## CONNECTICUT SITING COUNCIL

RE: **DOCKET NO. 364** - The Connecticut Light and Power Company application for a Certificate of Environmental Compatibility and Public Need for the construction, maintenance, and operation of a new bulk-power 115-kV to 23-kV substation located at 325 Waterford Parkway North, Waterford, Connecticut.

**Findings of Fact**

Figure 1: Site Layout

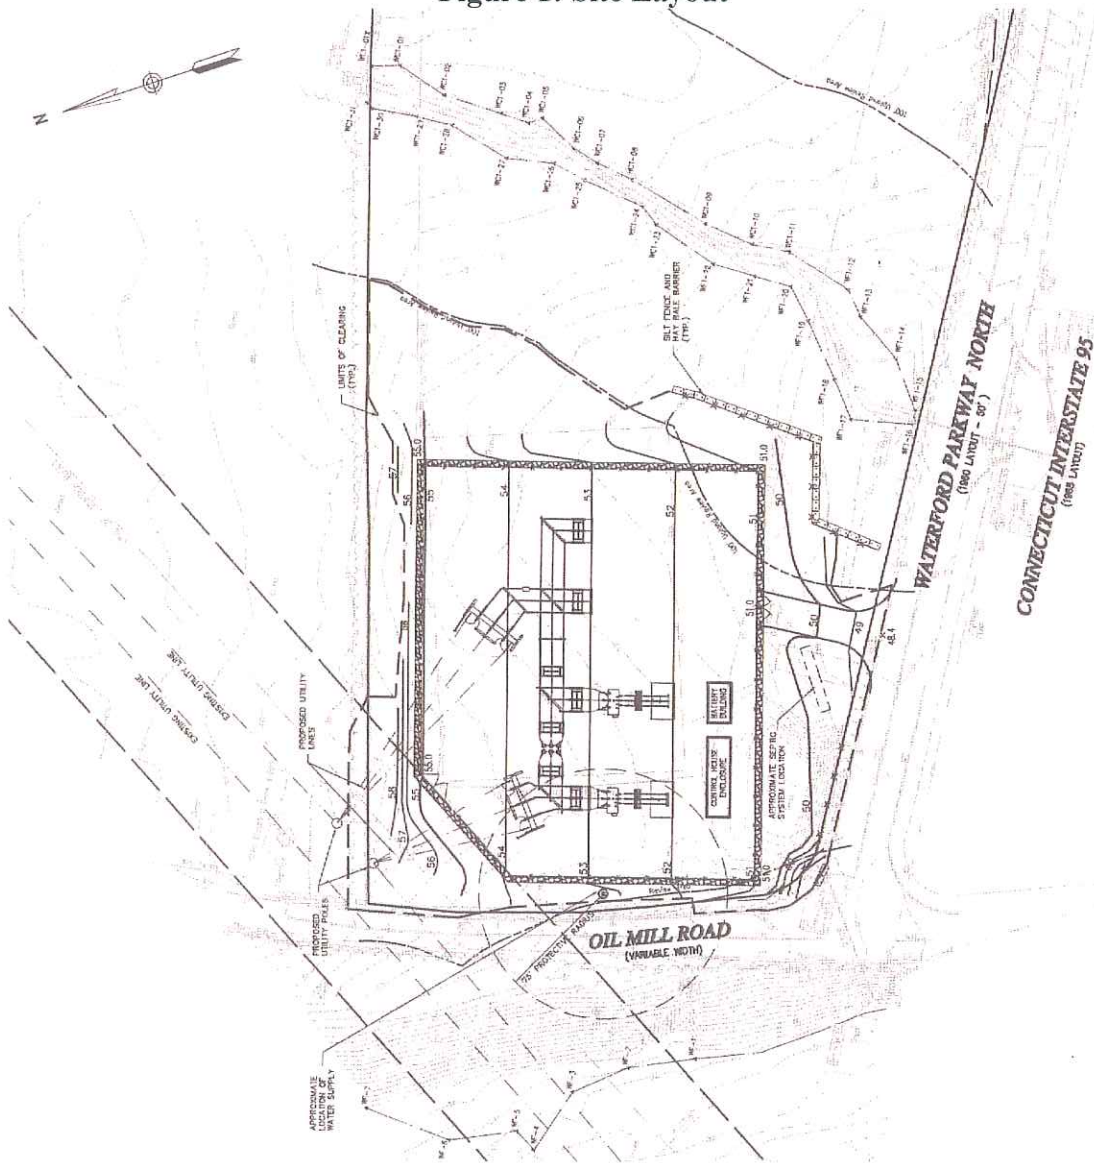
Construction of the access road and southeast corner of the compound would remove vegetation that may provide a buffer. Thus, the Council recommends shifting the substation 10 to 15 feet to the east and moving the southeast corner to allow for additional landscaping. The Council also recommends that the southwest corner of the substation be moved to accommodate additional landscaping, improve sight lines, and provide additional screening in the vicinity of the intersection of Oil Mill Road and Waterford Parkway North. These details can be reviewed in the D&M Plan.
